# STAFF REPORT

**Case:** RCC14-23

**Request:** Approval of a sign in the River Corridor, as required by Section 12.703(a) of the River Corridor Development Ordinance, to allow for a new freestanding (roof) sign with a total sign height of 36 feet, measured from the ground, and a total sign area of 75 square feet.

**Case:** Amendment to Case RCC14-13

Original Rendering of Proposed Cactus Sculpture Sign

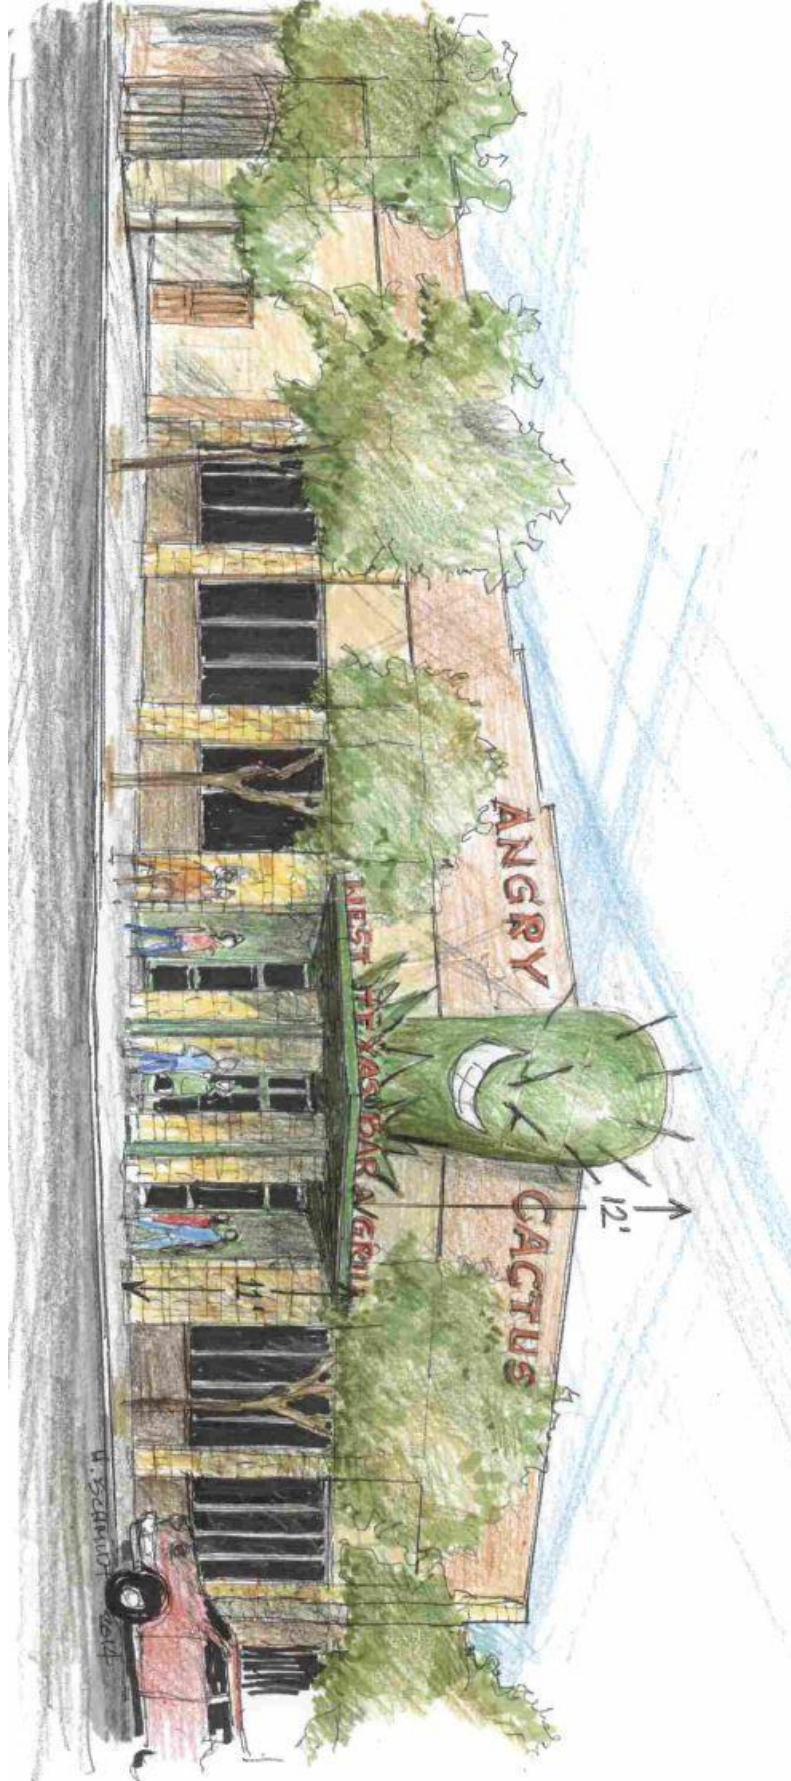
**As indicated, the applicant has made no changes to the cactus sign since the last DHRC Meeting of October 28, 2014. The applicant is requesting approval of a cactus sign with the same visual appearance and dimensions, 7.5 feet wide by 10 feet high on a 2 feet base, with a total sign area of 75 square feet. However, it should be noted that the proposed sign is expected to extend into the City right-of-way by at least three (3) feet. This protrusion will require that a Right-of-Way Encroachment agreement be approved by City Council prior to a Sign Permit being granted. This action is reflected in proposed Condition of Approval #5.**

The existing vacant building on the property was built in 1969 and covers the entire site up to the property lines. The applicant had stated he would have liked to erect a freestanding cactus on the ground in front of the building, but there is insufficient space. His only option was to erect the cactus on the roof. The sculpture is a unique feature used specifically to advertise the applicant's restaurant and to draw potential customers walking or driving downtown to the site. As indicated, the applicant was granted a sign variance from the Planning Commission to allow the roof sign to be 36

Staff would therefore support a subtle shade of green, whether light or dark for the sign, similar to the above developments in the area and the color palette of the National Trust for Historic Preservation. As a Condition of Approval, Staff recommends the applicant submit final colors and materials for the sign to the Planning Director, or his or her designee, for approval.

Staff conducted a second site visit on Monday, September 15, 2014, at night to look at the illumination of other signage in the River Corridor. Staff found a consistent type of lit signage in the area. Signs were lit from the back, usually with an LED light, but did not produce lighting that was excessively bright or that spilled over onto adjacent properties. Examples include the freestanding sign for J.L. Mercer Boots at 224 South Chadbourne Street, Stango’s Coffee at 221 South Chadbourne Street, The Deadhorse Music Lounge at 210 South Chadbourne Street, Grinners Daiquiri Bar at 217 South Chadbourne Street, Casa Décor Furniture Store at 39 West Concho Avenue and the “37” sign for Iggy’s Italian Ice at 37 West Concho Avenue in San Angelo (see photos attached). Such signage is consistent with other DHRC approvals where glare and light spill are minimized, such as the signage for the Twisted Root Burger bar/restaurant at 333 South Chadbourne Street (RCC 13-51) and for Angelo Mercantile at 135 West Twohig Avenue (RCC 12-54). As a Condition of Approval, staff recommends that any lighting proposed for the sign not be excessively bright or spill over onto adjacent properties.

1. **Approval of the Sign shall be consistent with dimensions per the attached renderings.**
2. **The sign shall be predominantly painted a shade of green that is consistent with the color palette of the National Trust for Historic Preservation for the Suburban Modern – 1950s period.**
3. **All exterior lighting shall be shielded and positioned in such a matter so as to not spill over onto any adjacent property.**

4. **Final color samples, signage renderings, and lighting details shall be submitted to the Planning & Development Services Director, or his or her designee, for final authorization prior to sign permit approval.**
5. **Prior to final approval of the sign permit, the applicant shall obtain a Right-Of-Way Encroachment Agreement from City Council for any portion of the proposed signage which projects onto a public right-of-way.**

Revised Renderings "November 17, 2014"

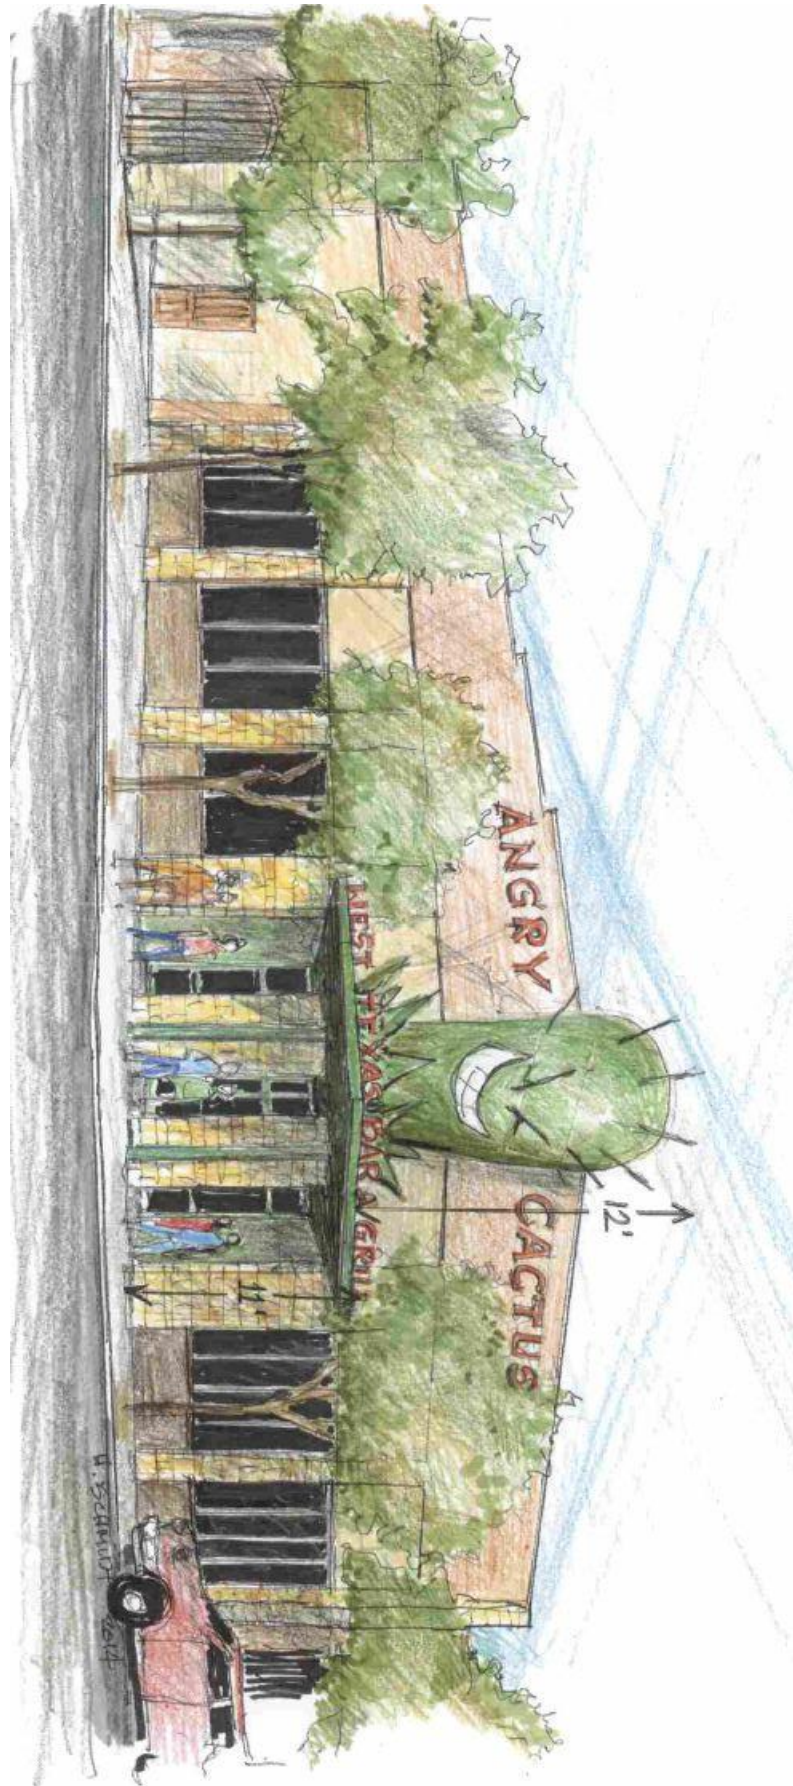
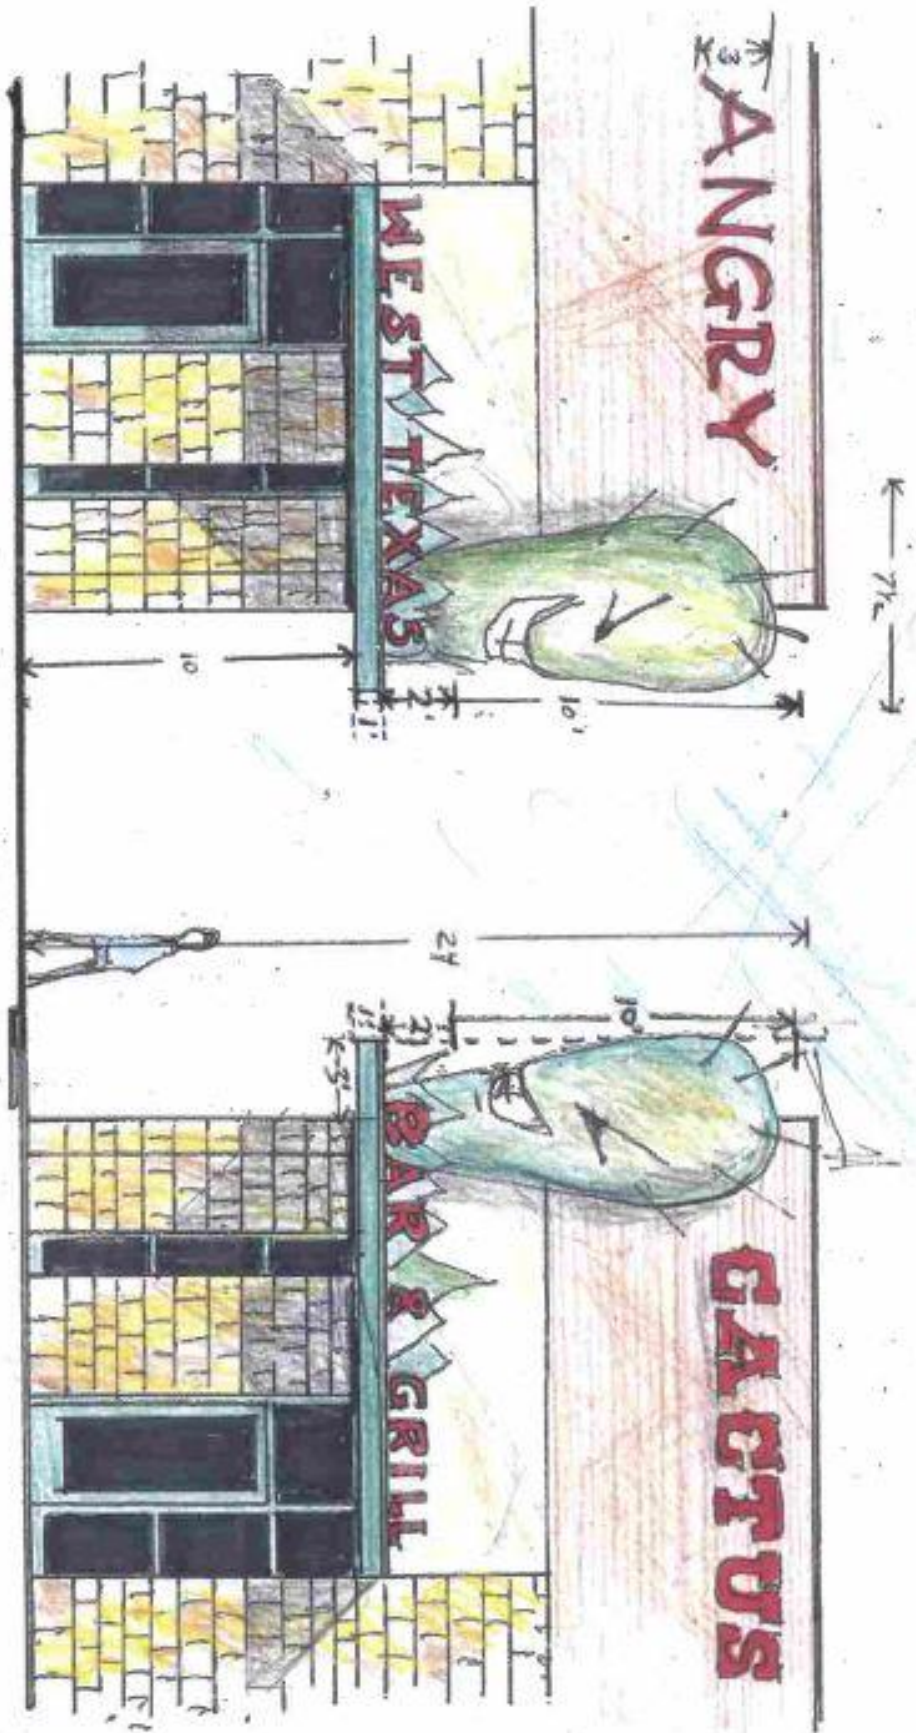
The revised submission shows fully scaled elevation drawings showing a new canopy at the front of the building at the corner of West Concho Avenue and South Chadbourne Street. The new canopy is 10 feet high and would project 3 feet into the street's right-of-way along the first 16 feet of both West Concho Avenue and South Chadbourne Street. The 10-foot high cactus sign, with a 2-foot base, would sit on top of the canopy, but as previously mentioned, will be reviewed by separate application pending (RCC14-23). Also shown are recessed building walls as required by the previous approval, however, it is unclear the projection distance between the projecting columns and the building walls.

The canopy as shown would include sign lettering for the restaurant "West Texas Bar and Grill." The façade colors and materials remain unchanged from the previous approval. The base would be a light brown or red brick finish, with a light yellow and red neutral stucco finish for the remainder of the building. The canopy would be a neutral green color and there would be some yellow brickwork underneath the canopy around the front entrance.

**Staff recommends that the applicant submit final plans prior to construction showing the projection distance between the new columns and the walls on South Chadbourne Street and West Concho Avenue.**

Staff also reviewed the new wall sign requests. The signage at the front of the building has been amended from “Angry Cactus West Texas Bar and Grill” to “Angry Cactus” only, with the “West Texas Bar and Grill” letters now on the canopy in the projection area. Each sign appears to be less than 25% of the wall area as required in 12.604 of the Sign Ordinance.

**The applicant has not included the two large thorns at the front corner of the building so they will be removed from this approval.**

- 1. The applicant shall submit final plans to be administratively approved by the Director of Planning & Development Services, or his or her designee, prior to construction, showing the final color scheme and**

building materials, signage, lighting, and variation to the building walls with columns, recesses and/or canopies to be consistent with the existing character of the area and with the attached renderings.

2. The applicant shall comply with all the standards outlined in the Sign Ordinance, unless otherwise indicated or waived.
3. All illumination shall be designed in such a manner so as to minimize the potential for glare and unnecessary diffusion onto adjacent property and rights-of-way.
4. The applicant shall obtain a Right-Of-Way Encroachment Agreement from City Council for any required grease trap, signage, and portion of the building which projects onto a public right-of-way.

1. The two thorns shown at the front of the building as part of the original submission approved on June 19, 2014, have been removed and shall no longer be part of this approval.
